**Inspection Report
120-122 Saunders Street, Pyrmont**

Council Investigation Officer Inspection and Recommendation Report; Clause 17(2) Part 8 of Schedule 5 of the Environmental Planning and Assessment Act 1979 (the Act)

**Re: INSPECTION REPORT
BAYVIEW TOWERS
120-122 SAUNDERS STREET PYRMONT (hereafter "the premises")**

Image 1 - FIP block plan changed to reflect inaccurate zone addressing

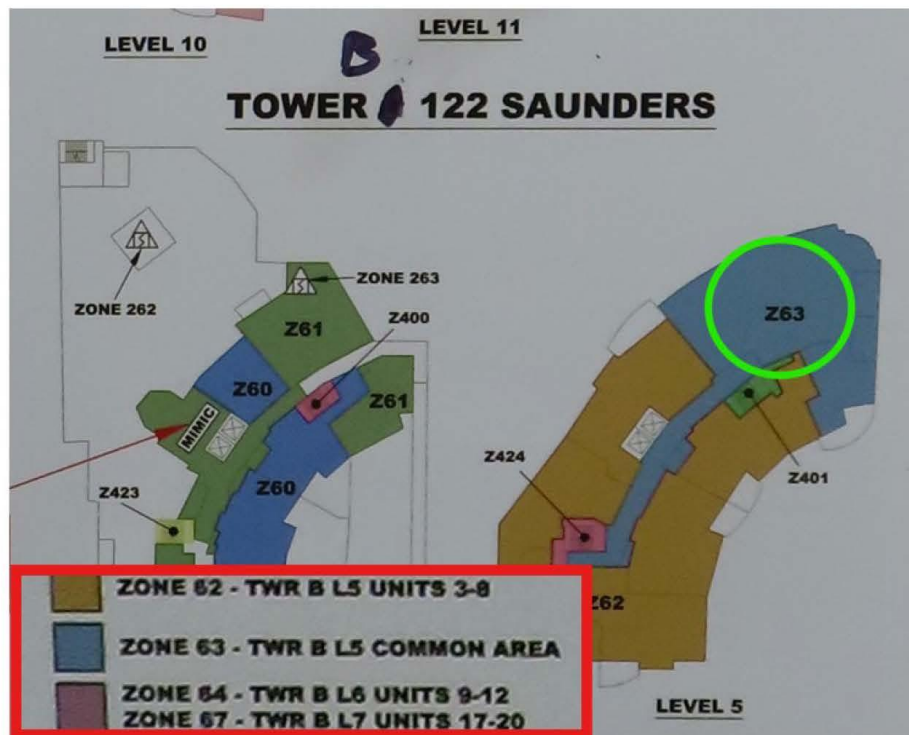
- C. The zone addressing of the fire indicator panel and the building identifiers create confusion for firefighters attending calls of fire at the premises. The block plans have been modified by permanent marker to compensate for FIP addressing.

E.g. The FIP address for Zone 63 is *ZONE 63 – TWR B L5 COMMON AREA* and along with the floor plan, shows Zone 63 as being in Tower B (Figure 1). Zone 63, though, is in Tower A.

When firefighters are advising occupants, they are going to TWR B L5, the occupants direct them to Tower A. Should an incident occur that requires greater FRNSW resources, the incident controller may not be able to provide adequate safeguards to firefighters as firefighting crews may be sent to the wrong building based all information available to the attending crews.

- a. Review items 1 and 2 (excluding item 1A(A)) of this report and conduct an inspection.
- b. Review the addressing of the fire indicator panel and/or building identifiers.
- c. Address any other deficiencies identified on the premises.
